**CUSTOMER INFORMATION LETTER**  
**FIELD SAFETY NOTICE (FSN)**

**Tempus LS**

**Incorrect ECG waveform and Pacing spikes possible when  
changing from Pacer Mode to Manual or AED Defibrillation Mode**

### AED Defibrillation Mode Fault Condition

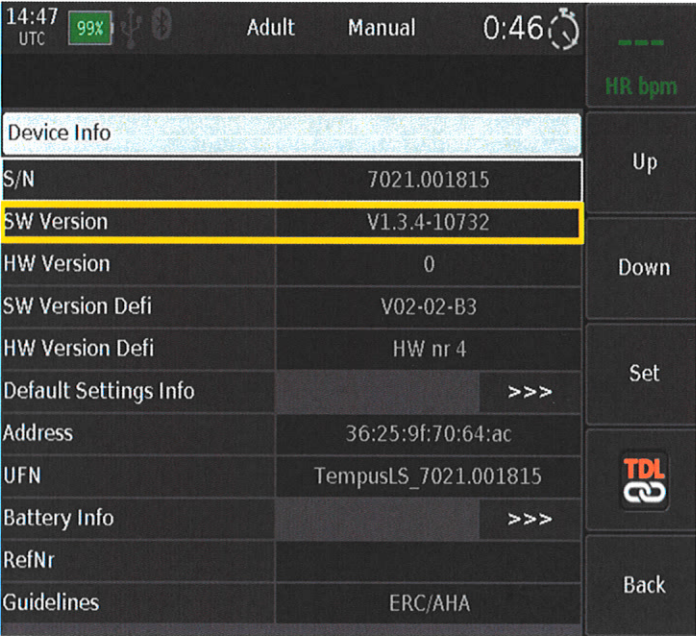
This may result in inability to deliver therapy. When the problem exhibits itself the device inadvertently displays and mimics Asystole for the connected patient, when another heart rhythm may be present. The device identifies the patient as being Asystole, and therefore in AED mode does not recommend a shock and a shock is not possible to deliver.

<p><b>ACTIONS PLANNED BY THE MANUFACTURER</b></p>	<p>The root cause of the software error has been identified and a fix will be made available in Tempus LS Software Version: 1.3.5.</p> <p>This software update will be made available to users as a field correction via the exclusive Distributor Remote Diagnostic Technologies Ltd, a Philips company.</p> <p>RDT will contact affected customers to arrange a field update of device software.</p>
<p><b>FURTHER INFORMATION AND SUPPORT</b></p>	<p>If you need any further information or support concerning this issue, please contact RDT Customer Services or your account manager:</p> <p><a href="#">&lt;Country Distributor Contact Details&gt;</a></p>
